### ENVIRONMENTAL ASSESSMENT AND FINDING OF NO SIGNIFICANT IMPACT

#### EVANSVILLE WATER & SEWER UTILITY CSO 004 Relief Sewer Project SRF PROJECT WW 14 21 82 16

Re: Evansville, Vanderburgh County, Pigeon Township  
PER G Project # 1  
CSO 004 Relief Sewer Project  
State Revolving Fund Project WW14 21 82 16, DHPA #19470

**EXHIBIT  
 1-12C**

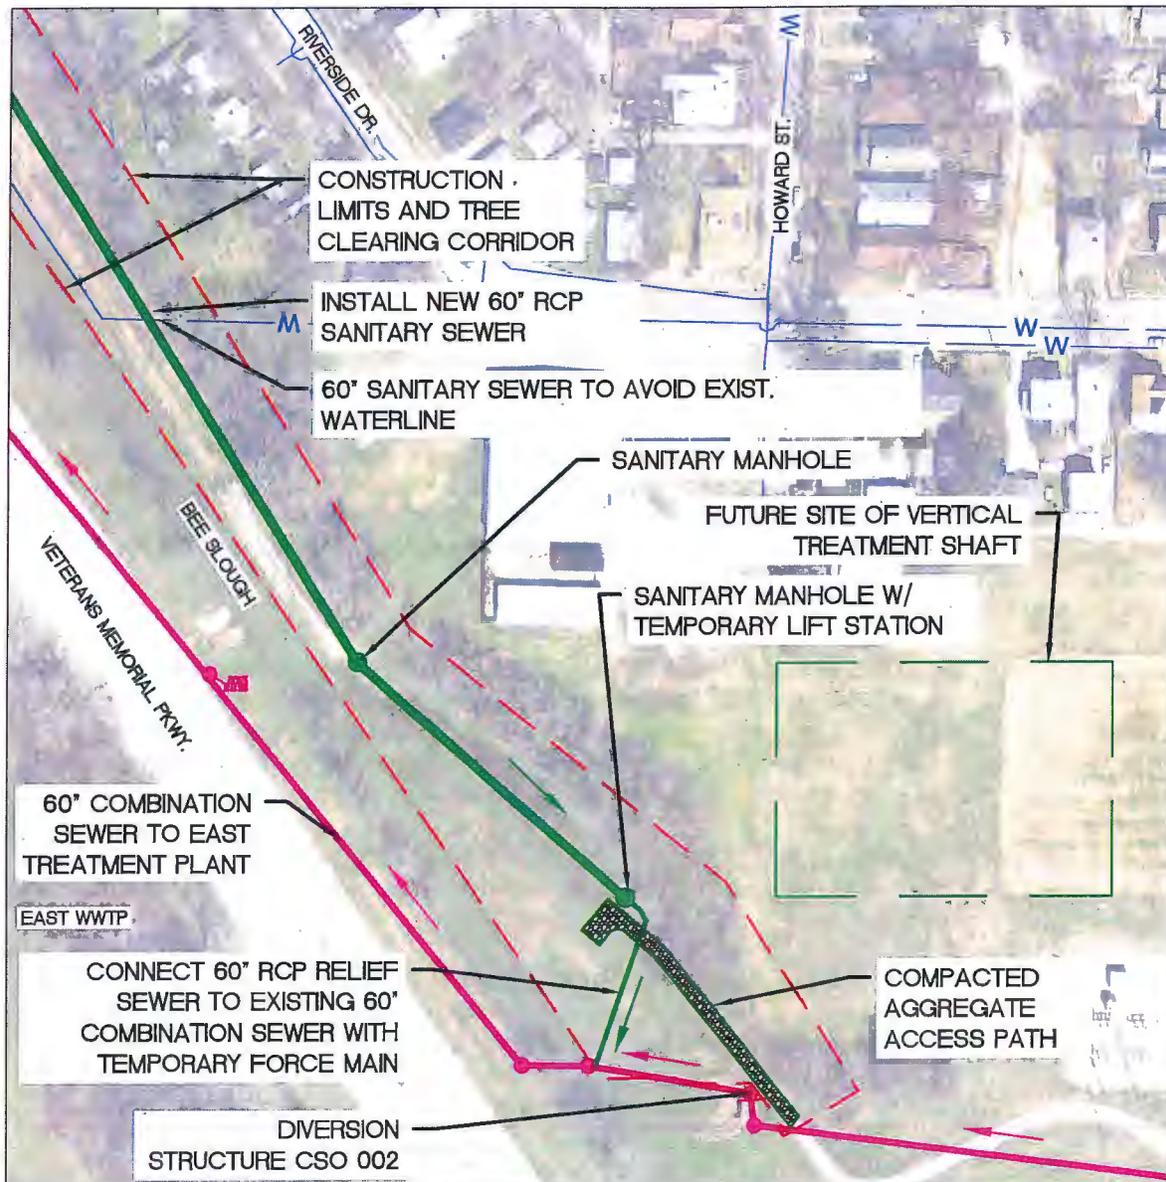
a. Is it possible to receive a site plan and rendering showing exactly what trees will be removed, what trees will remain, as well as where the double row of evergreens will be planted specifically for the 20 Shawnee Drive property?

b. Is it possible to keep at least all of the trees located within the National Register boundary and still plant the additional evergreens?

A Planting plan has not been developed. However, a sketch identifying which trees will be removed and which trees remain specific to 20 Shawnee Drive has been included in this submission.

Tree removal as previously described (See Exhibits 1-12A thru C) and the exhibit specific to 20 Shawnee Drive are required to construct the project.
